**BEFORE THE COMMISSIONER APPOINTED BY
THE OTAGO REGIONAL COUNCIL**

IN THE MATTER BSTGT Ltd and A P McQuilkin, N
J McQuilkin, K L Skeggs, S A
McQuilkin and G M Todd being
Trustees of the A P McQuilkin
Family Trust
Consent Application RM19.151

**EVIDENCE IN REPLY OF HILARY LENNOX
ON BEHALF OF BSTGT LTD AND
A P MCQUILKIN, N J MCQUILKIN, K L SKEGGS, S A MCQUILKIN AND
G M TODD BEING TRUSTEES OF THE A P MCQUILKIN FAMILY TRUST**

Figure 1: The independent catchment areas of New Chums, Tri Burn and Royal Burn

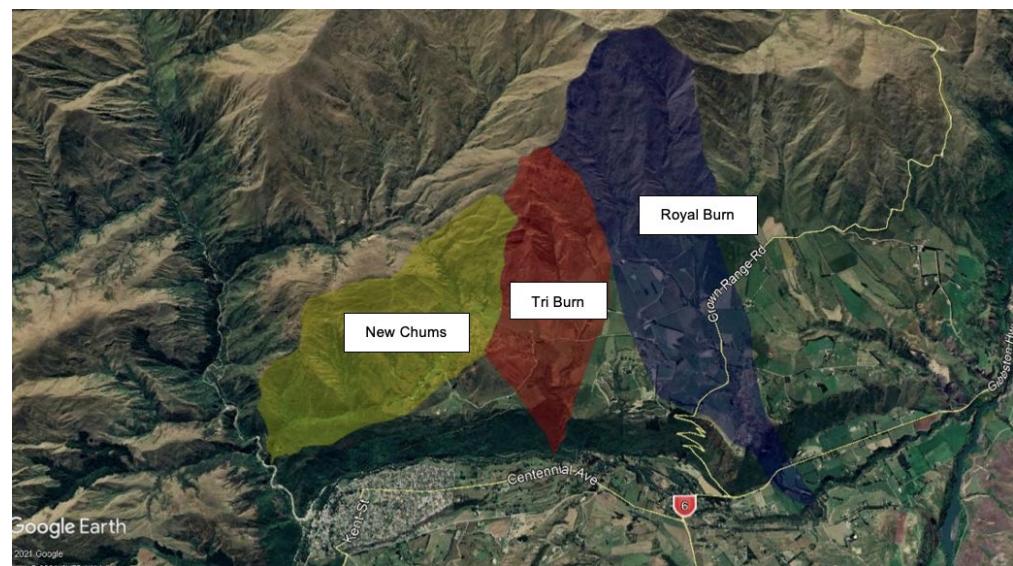
9. Mr Whyte has ignored the Tri Burn catchment, which lies in between the New Chums and Royal Burn catchments. Mr Whyte in his Figure 1 has mistakenly combined the Tri Burn catchment with his New Chums Creek catchment while also overstating the size of the Royal Burn catchment. My figure below corrects this. The extent of these catchment area errors means that the figures in his Table 1 are incorrect.
